**BMP NUMBER: PC130**

# Stormwater Division

Upper wet pond located on the north side of the main entrance road; Combined folder with PC033

**MASTER GRADING, DRAINAGE &  
EROSION SEDIMENT CONTROL PLAN**  
FOR THE CLUSTER DEVELOPMENT  
**LONGHILL GATE**

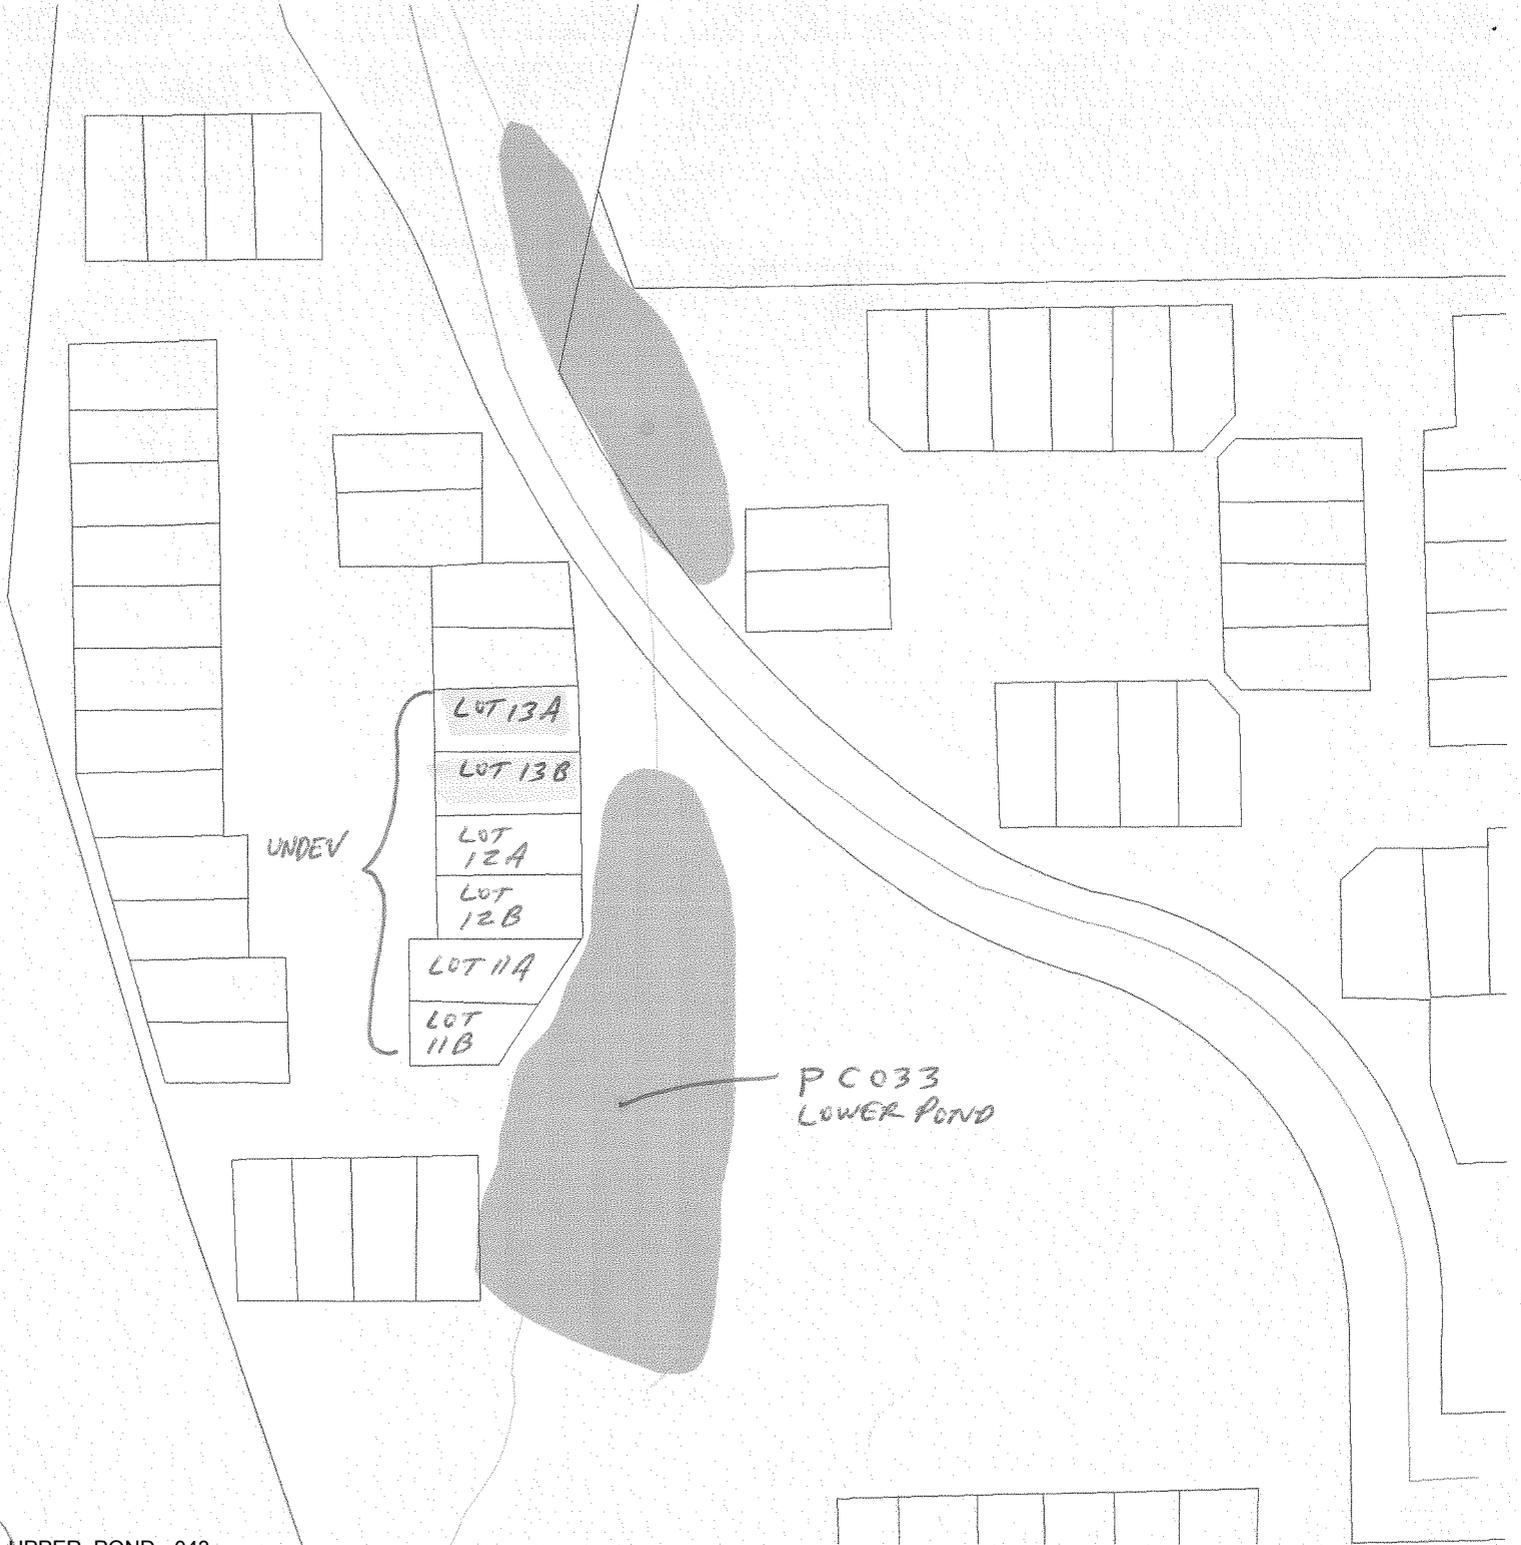
Based on our record files, design high water elevation is not specifically stated for this BMP facility. However, based on record hydraulic computations for the emergency spillway, depth of flow for design parameters specified ( $Q=50$  cfs, 8' wide,  $n=0.050$ , 1 percent slope, 2H:1V sideslopes) would result in a flow depth in the spillway of 1.45 ft., which would equate to El. 57.95. However, in lieu of formal computations, reasonable conservative assumptions will be used to establish design high water elevation. Assuming dam design met minimum requirements, there would normally be 1 foot of freeboard between top of dam El. 58 and 100-year design high water. Therefore, the assumed minimum 100-year design high water elevation for the adjacent wet pond facility (County BMP ID Code: PC 033) is at Elevation 57.0. Original plans and computations were prepared by Spearman & Associates of Williamsburg, Virginia under approved County Plan No. SP-4-86.

Show the 100-year design high water elevation on the plan and the location of the landward 25 ft. pond buffer/setback. Efforts should be made to not situate clearing, grading or permanent structures in the buffer and to preserve existing trees and vegetation in the buffer to the greatest extent possible. If clearing, grading or permanent structures are situated in the pond buffer a written request for waiver is required to be submitted to the Environmental Division. The waiver request shall include supporting information as required including: stabilization or landscaping plan to restore disturbed buffer area back to meadow or forest condition using native trees, shrubs or ground cover to the greatest extent possible. If permanent structures are situated horizontally in the buffer, provisions are required to keep adequate vertical separation between design high water of the pond and the finished floor elevation of the structure. The variance request needs to be from the owner or tenant, current or future, rather than the builder or contractor.

**Lot 13B, Tower Hill Section of Longhill Gate (5321 Tower Hill)**

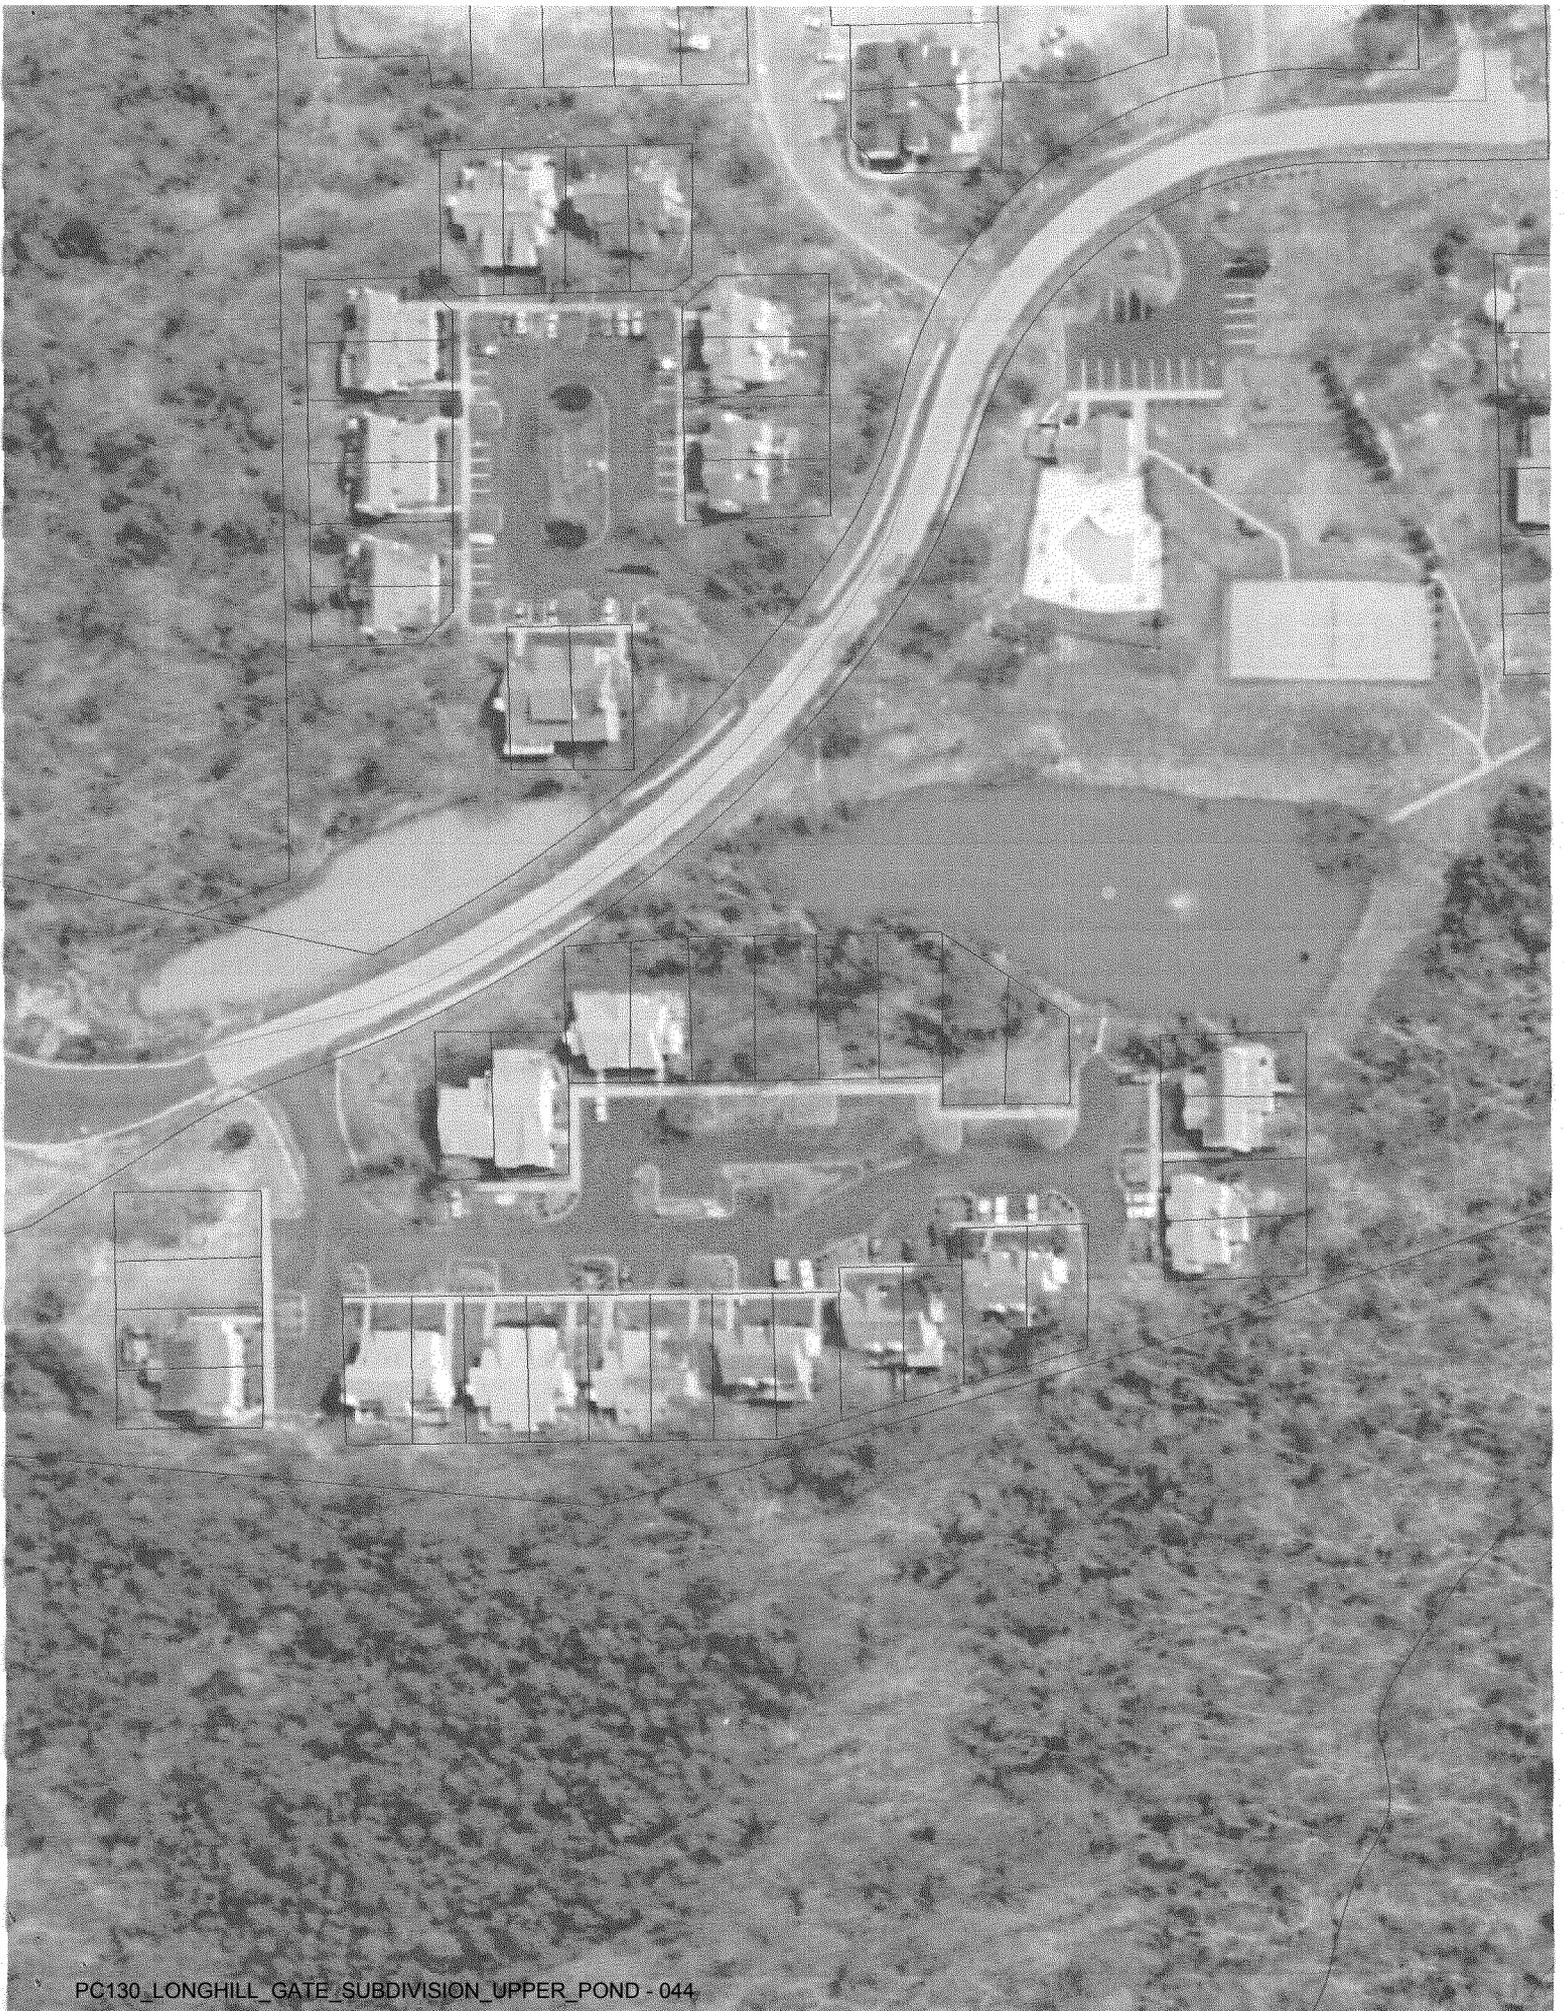
Show the 100-year design high water elevation on the plan and the location of the landward 25 ft. pond buffer/setback. Efforts should be made to not situate clearing, grading or permanent structures in the buffer and to preserve existing trees and vegetation in the buffer to the greatest extent possible. If clearing, grading or permanent structures are situated in the pond buffer a written request for waiver is required to be submitted to the Environmental Division. The waiver request shall include supporting information as required including: stabilization or landscaping plan to restore disturbed buffer area back to meadow or forest condition using native trees, shrubs or ground cover to the greatest extent possible. If permanent structures are situated horizontally in the buffer, provisions are required to keep adequate vertical separation between design high water of the pond and the finished floor elevation of the structure. The variance request needs to be from the owner or tenant, current or future, rather than the builder or contractor.

**Photo 10 –  
Highgate Green**  
Note the cracks in the paved ditch section; there is also evidence of large voids beneath the paved channel in several locations.

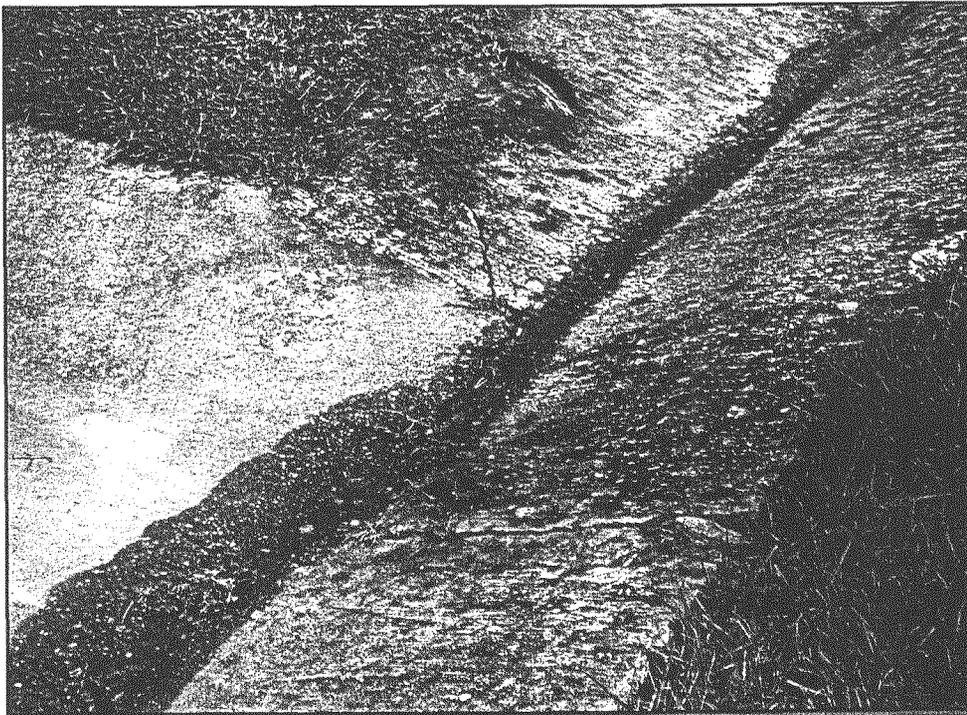
- Repair all ditches. (See Photo 10) Two paved ditch repairs were specifically mentioned in the original assessment, *Tower Hill* and the paved ditch at the end of the *Highgate Green* parking area that outfalls to the pond behind the recreation area. The latter paved section still suffers from the lack of proper support, due to either subsidence of the earth or “washout” of the soil beneath the paved ditch. To repair the paved ditch, AES suggests that all cracks and joints near the repair be sealed to prevent water removing the soil beneath the ditch. Then the concrete or flowable fill should be

pumped into the void regions. All paved ditches, which have become broken and misaligned due to lack of proper support must be repaired or replaced. AES suggests the damaged section of the ditch be removed between the crack control joints, the voids in the earth filled with compacted fill material, and a replacement paved ditch be constructed using fiber reinforced concrete.

**Photo 13 – Longhill Gate Entrance Road Causeway**

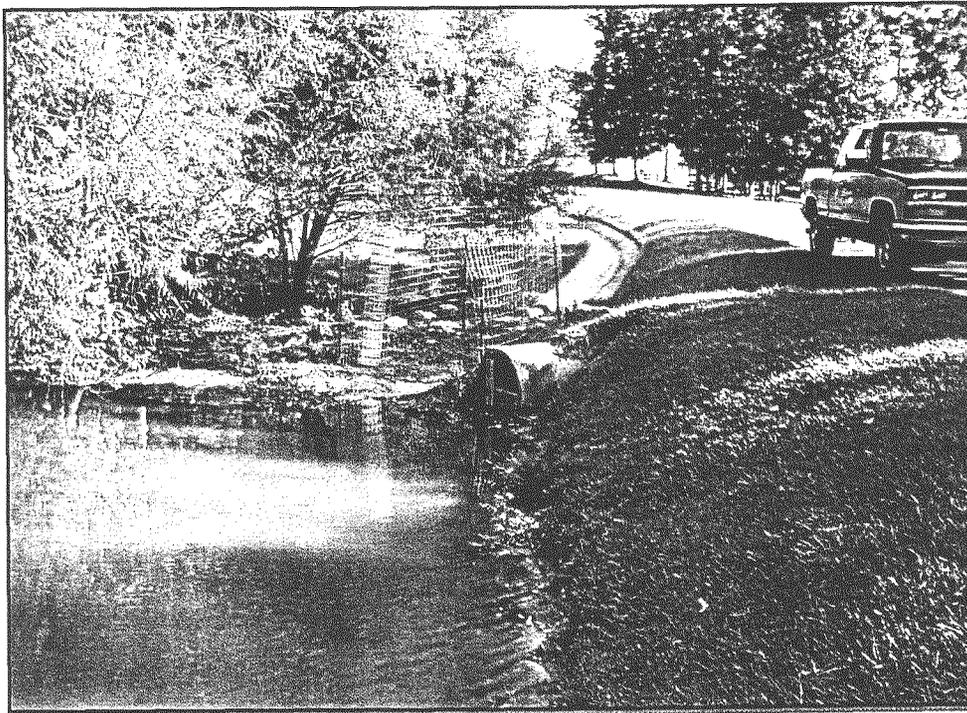
Another area of concern was found along the entrance road between the *Tower Hill* and *Sloane Square* sections of *Longhill Gate*. (See Photo 13) As can be observed by the photo, the surface is eroding away most likely due to large volumes of runoff flowing over the roadway's shoulder. It appears the grass shoulders being higher than the roadway surface cause the problem; once at the low point of the roadway, the storm runoff accumulates, overtopping the shoulder. The result is an eroded channel to the adjacent pond. AES recommends that forming a concrete channel approximately 9-inches in depth along the current eroded channel centerline repair this channel. This should provide an adequate solution and alleviate any further erosion problems. In the previous assessment, AES recommended that the road shoulders be graded to be slightly lower than the surface of the adjacent roadway. We still recommend the solution as the long-term repair.

Slope failure due to weakened state of earth caused by excess water runoff.

**Photo 19 – Tower Hill**

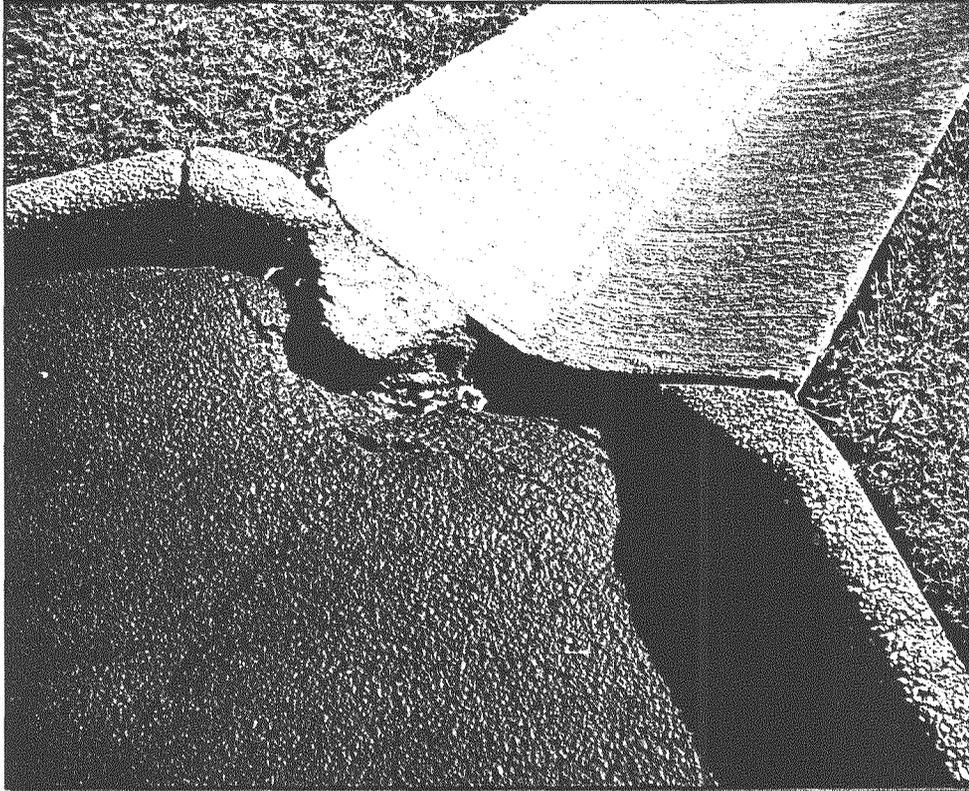
A pedestrian hazard was noted in the Tower Hill section (see Photo 19), this should be alleviated by a smooth transition of asphalt to the concrete swale. This will prevent the undermining of the drainage way as well.

Maintenance potential and pedestrian hazard. A smooth transition should be provided to the concrete ditch section.
